OPTIONAL SERVICE BULLETIN

OSB 42-144

Modification of the breather line installation.

WI-OSB 42-144

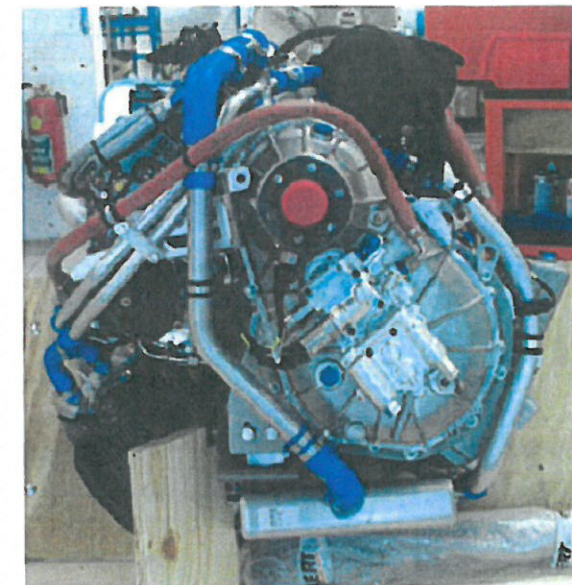
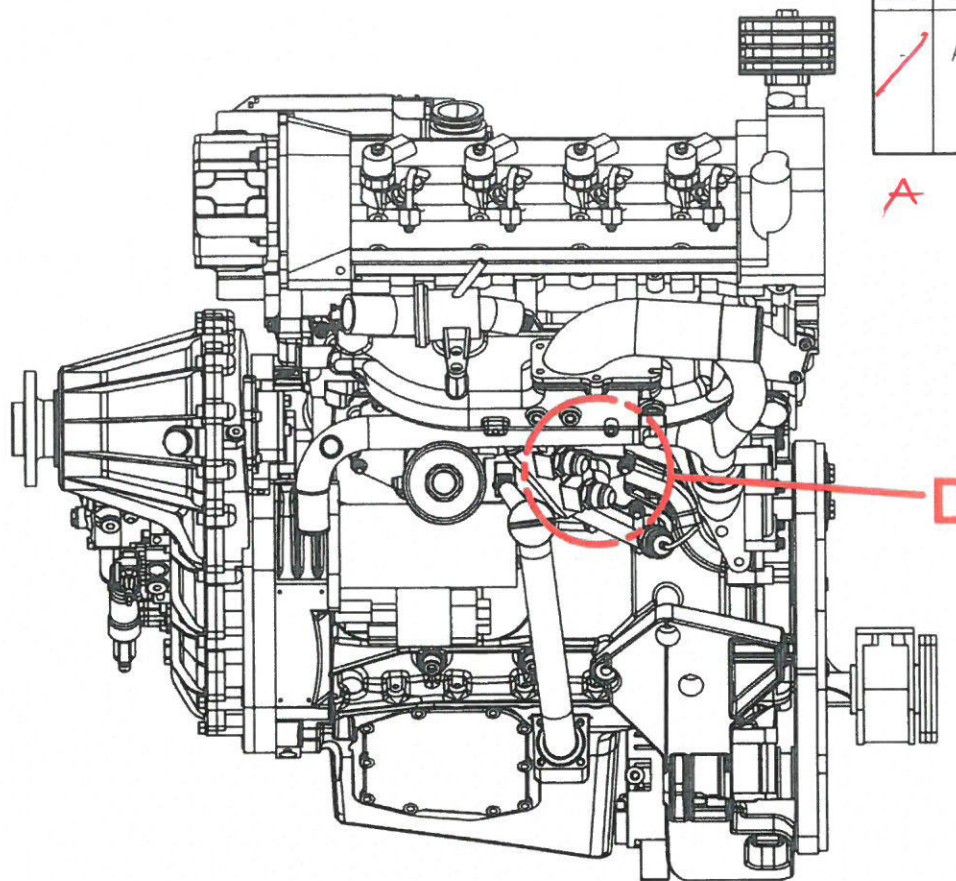
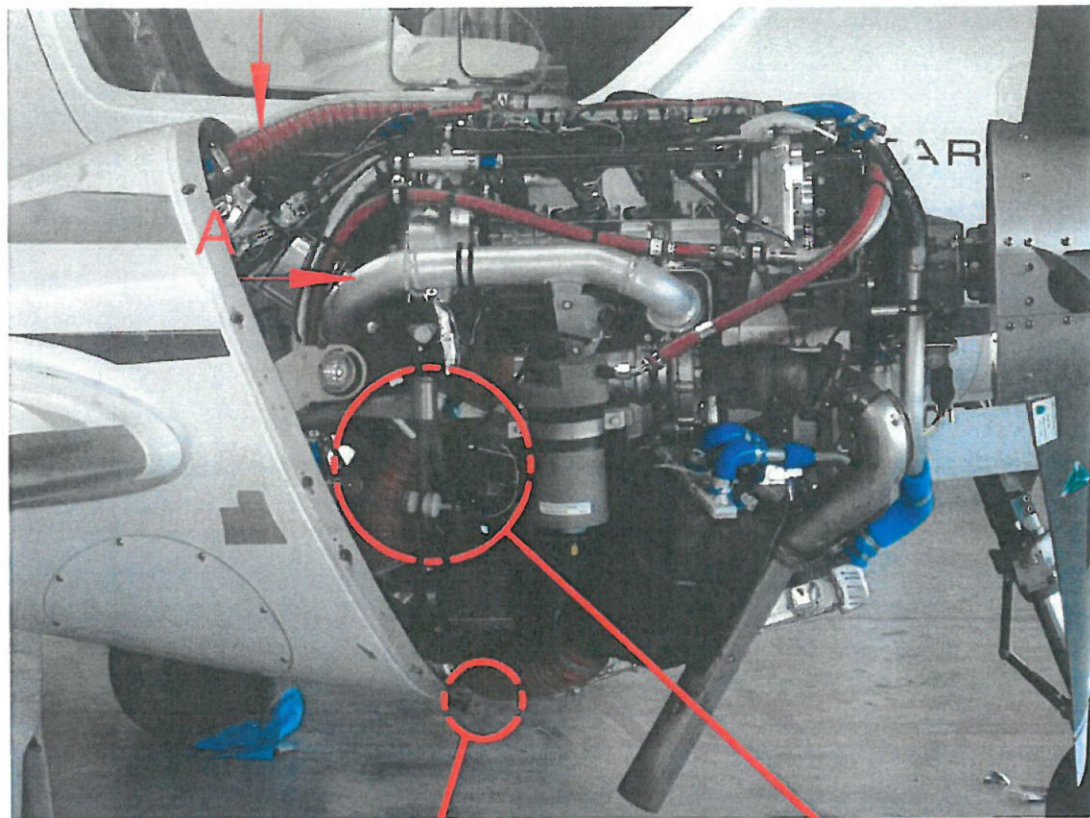
1. Install the breather line on LH and RH engine installation:

Install the breather line in pre-assembled breather assy clamps in according to drawing D60-7906-00-00_02 View A and Detail B, tighten clamps and install drain line.

Use tie wraps to attach the drain line on the engine mount.

Install the chafing protector on the engine mount (SHL 16_70mm).

Note: On the LH side the alternate Air Bowden Cable must be in front of the breather line.

DETAIL B

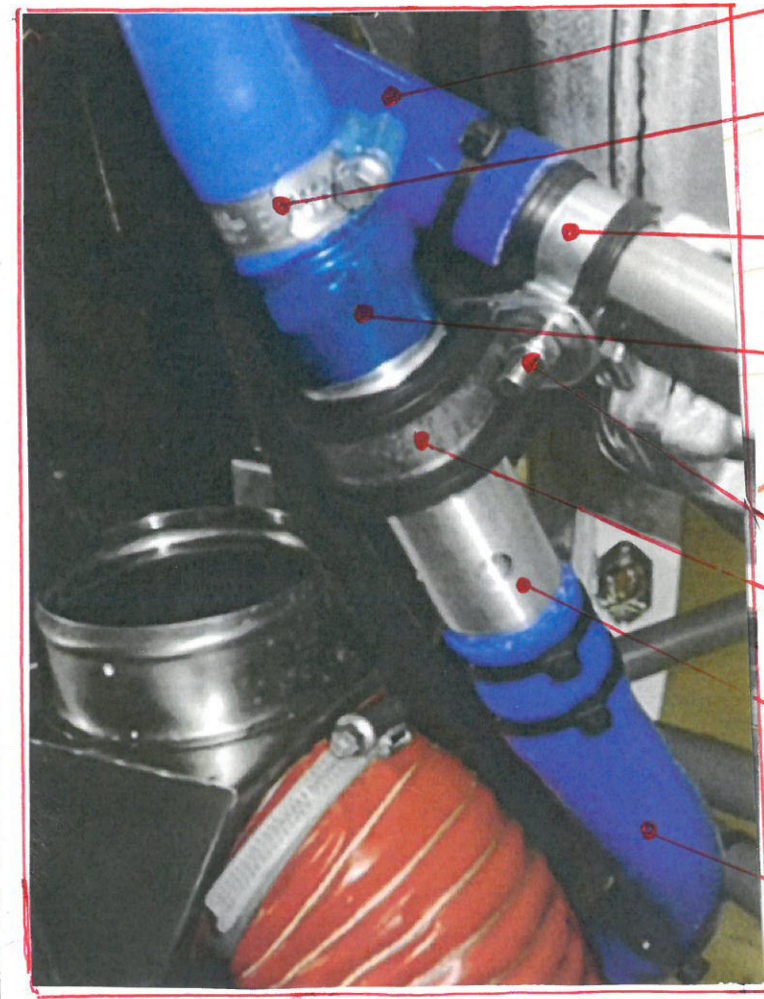
1 Install chafing protection on engine mount with tie wraps.
